Re: Apartments at 633 Adams Street NE, Traffic Circulation Layout
Architect's Stamp dated 11-14-09 (J17-D032)

**Re: 633 Adams St NE, New Building Grading and Drainage Plan
Engineer's Stamp dated 3-3-10 (J17/D032)**

**Re: Apartments at 633 Adams Street NE, Traffic Circulation Layout
Architect's Stamp dated 11-01-09 (J17-D032)**

**Re: Apartments at 633 Adams Street NE, Traffic Circulation Layout
Architect's Stamp dated 10-26-09 (J17-D032)**

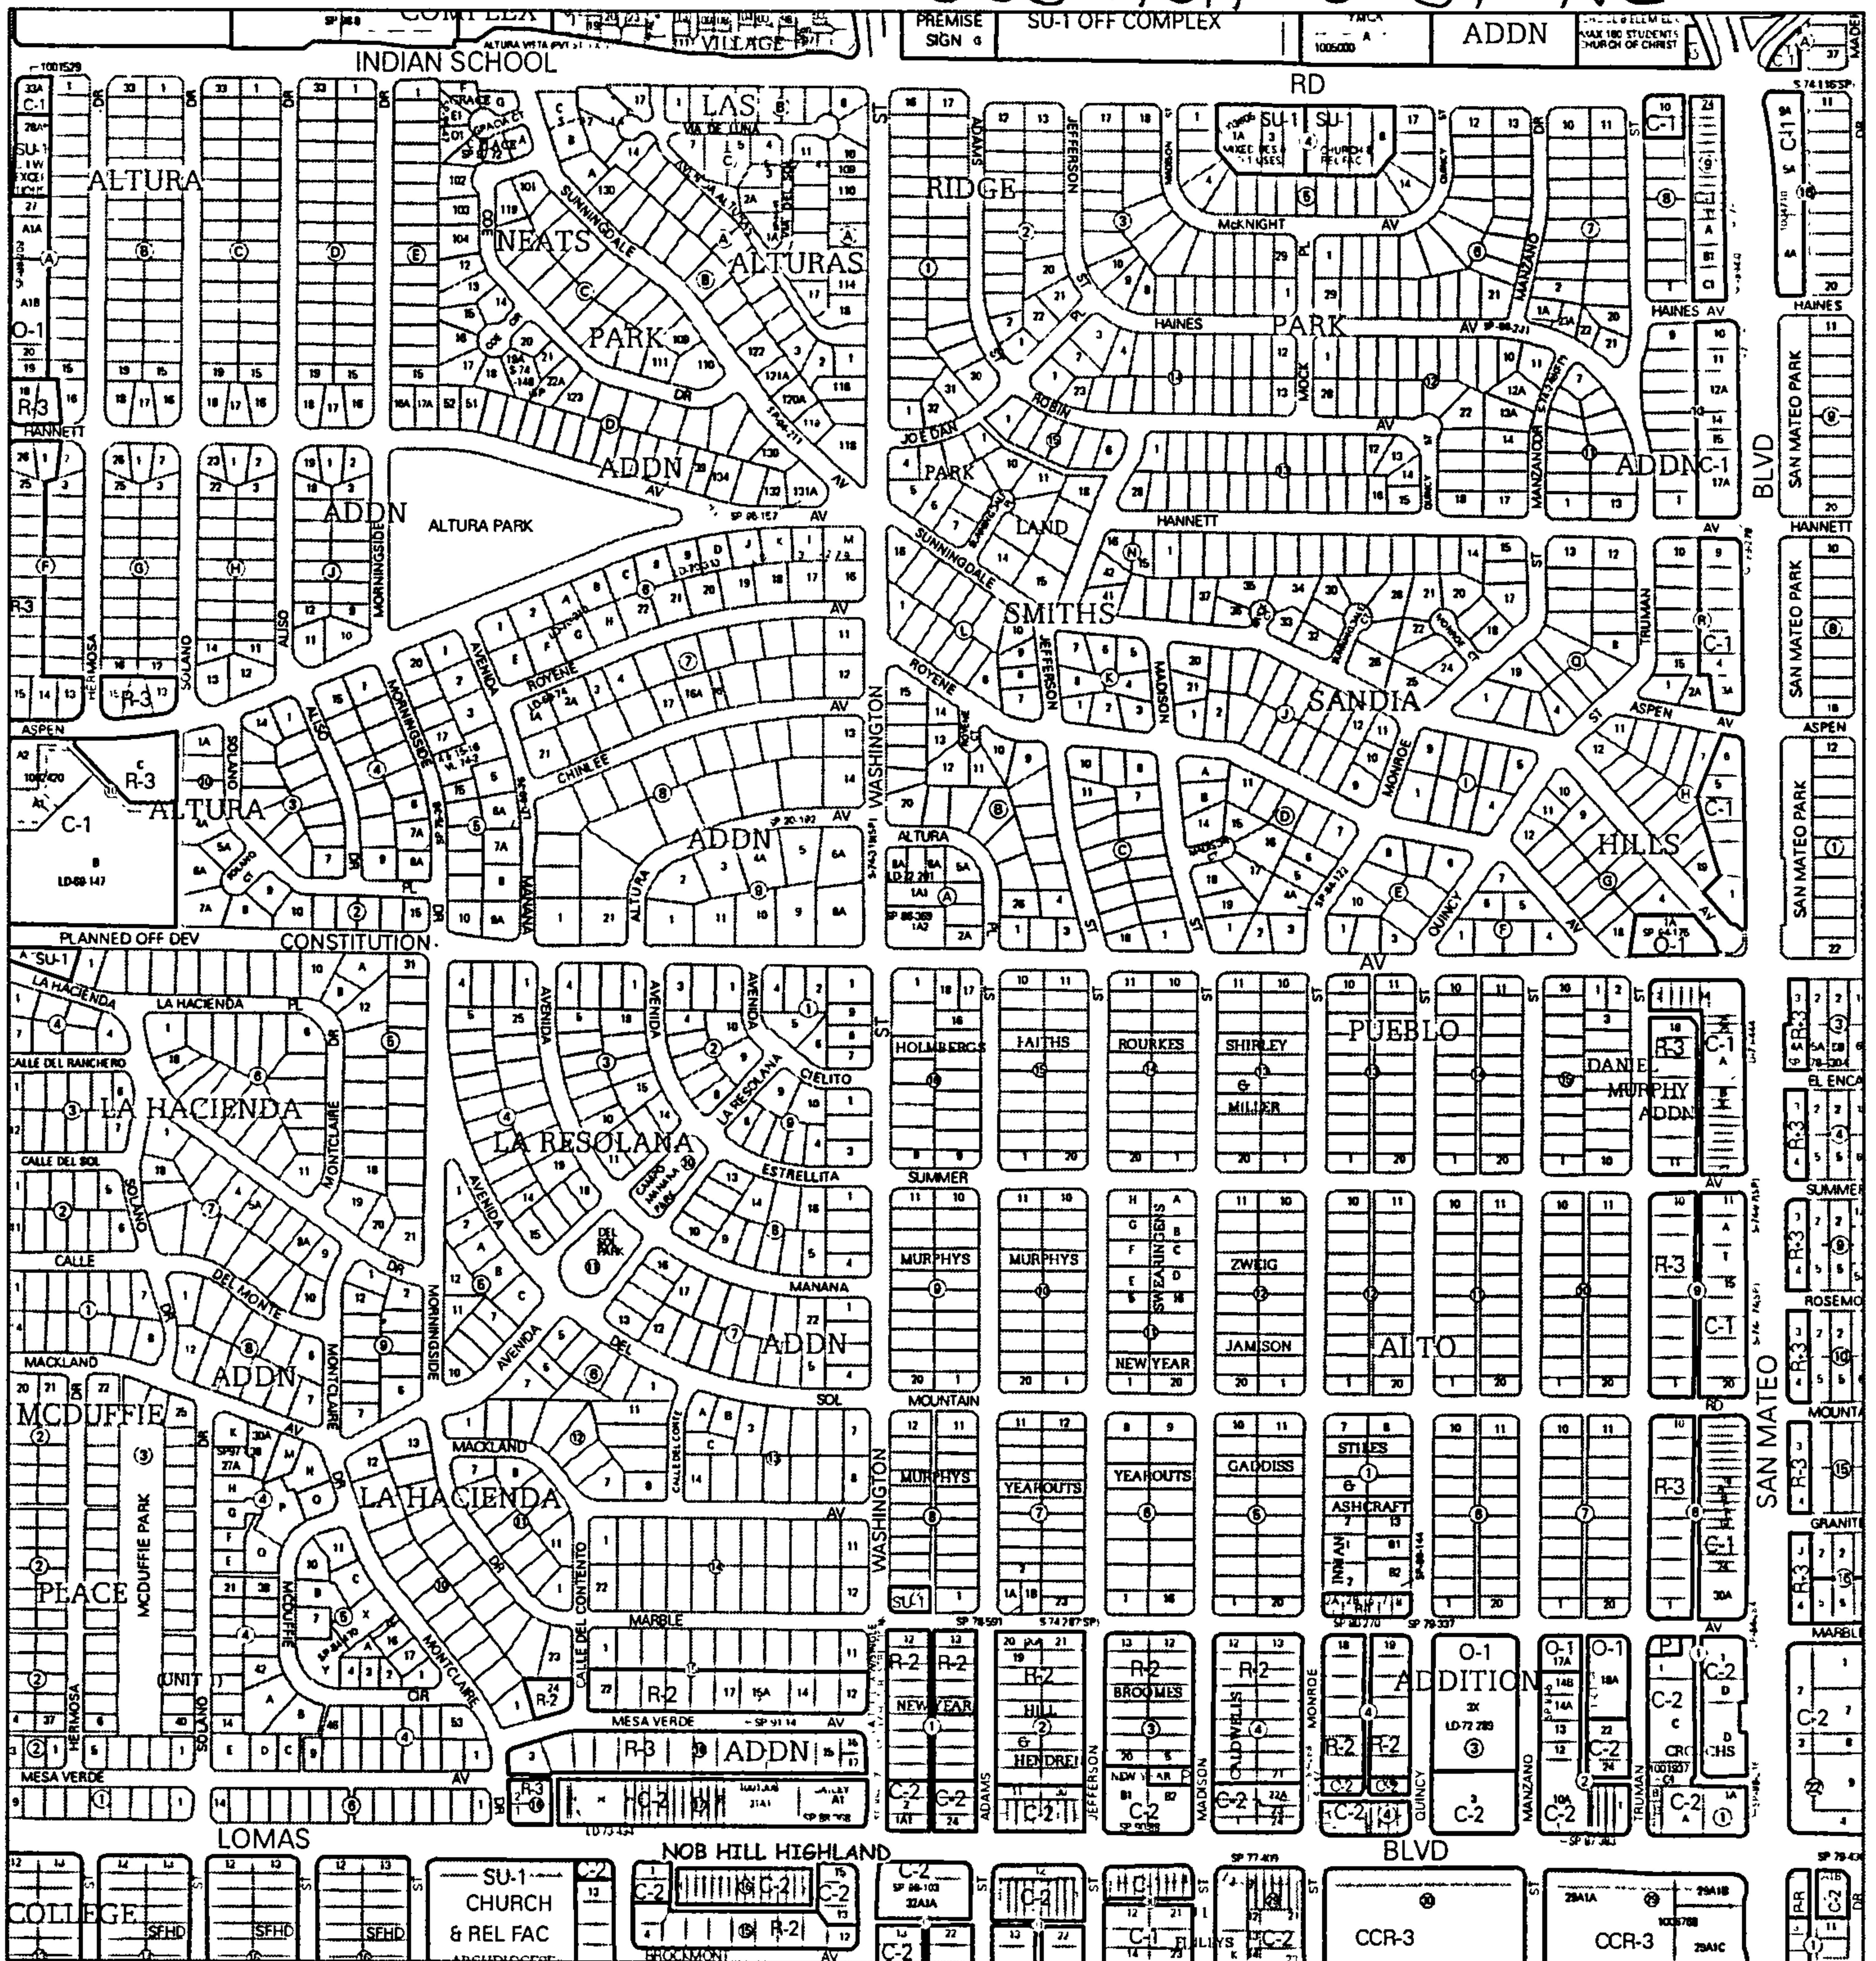
Vicinity Map

Parking Calcs

Geometric Data (aisle widths, parking stall dimensions, SW widths, entrance widths)

Need 6' wide ADA pathway from street

Need 6' wide ADA pathway for HC spaces

- show pathway from bldg

Condition of alley - paved or unpaved?
